# MEMO

RE: MPW Stage 3 (SSD 10431)—Response to [REDACTED] Submission

Figure A-5 AM peak one hour traffic volumes with MPW Stage 2 construction traffic – Scenario 2 (Stage 2) in 2018

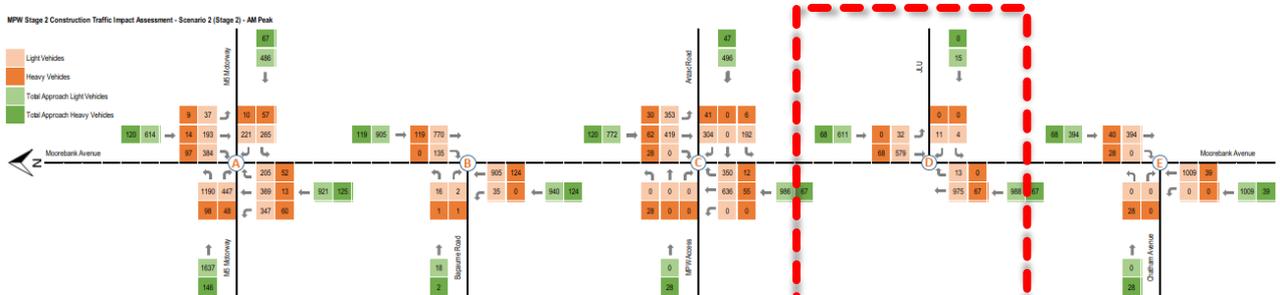
The [REDACTED] submission questions the change in link volumes between the intersections of Anzac Road and Chatham Avenue in Figure 5 of the submitted (April 2020).

As outlined above, that figure is provided for context only and does not replicate the MPE IMEX / JLU access from the Arcadis figures, hence there is actually an intersection between whereby some traffic may naturally ‘disappear’ from the network.

However, the submission has failed to realise that there are substantial accesses between Anzac Rd and Chatham Ave whereby this occurs. Refer below highlighted intersection from the original Arcadis figures.
